## Product Change Notification

TRIMPOT® TRIMMING POTENTIOMETERS

REVISED MAY 30, 2014

### New Housing Design for Model 3386 T Version Trimpot® Trimming Potentiometer, All Pin Styles

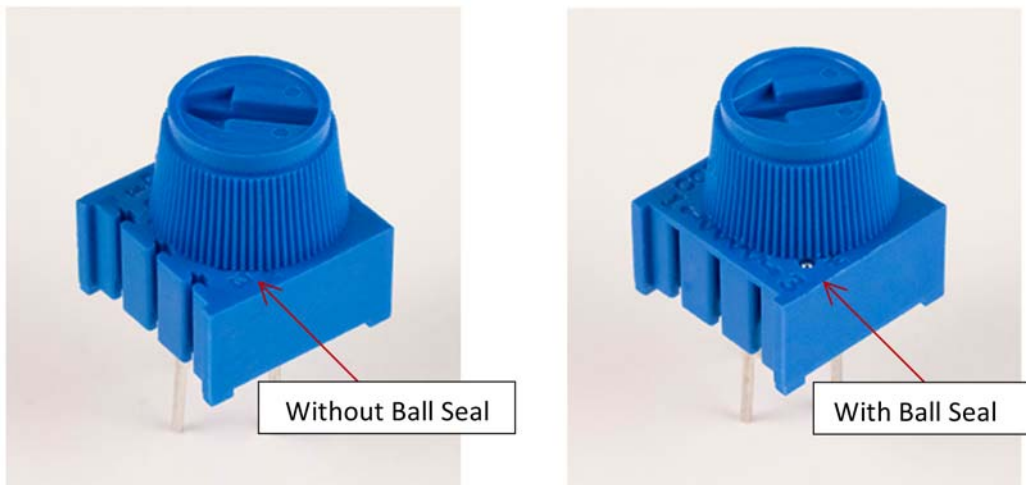
Bourns Trimpot Product Line announces a new housing design for the Bourns® Trimpot® Trimming Potentiometer [Model 3386 T Version](#), all pin styles. This change applies to the model with the knob feature and/or extended rotor.

There is no change to fit or function. However, the new design requires a ball seal on the housing, which changes the form. There are no changes to any of the electrical specifications or to the performance of the product. The first date code to identify the changed products will be 427C.
